# Housing Development

Parkview  
309 Blackness Road  
Dundee

## SUMMARY OF REPORT

**Figure 2 – Proposed East Elevation – Flats and Muse Building**

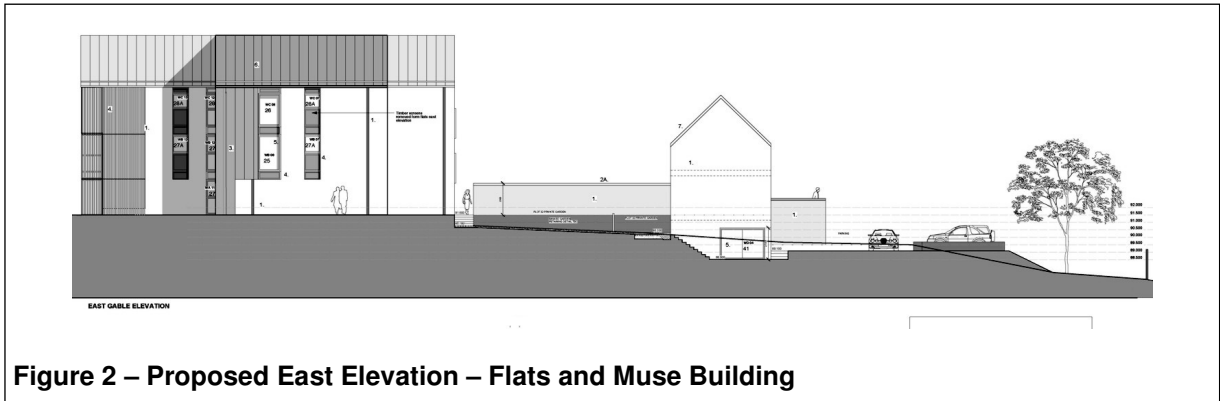
- 7.3 The omission of the timber screens over the east facing windows of the 3 storey building under construction will still retain the same form and scale of the approved development and will not dilute the quality of design or finish.
- 7.4 The revised proposals may impact on the amenity of neighbouring properties by virtue of the overlooking of private garden grounds. However, as discussed in the assessment of the proposals against Policy 9 below this matter can be overcome through conditions requiring the offending windows to be obscurely glazed.
- 7.5 **The proposals satisfies the requirements of Policy 7.**

- 9.1 It is recommended that consent be GRANTED subject to the following condition:
- 1 Window openings WB08 and WC08 serving the kitchen, living and dining areas of Flats 40 and 44 of the three storey building hereby approved shall be obscurely glazed and maintained as such in perpetuity.
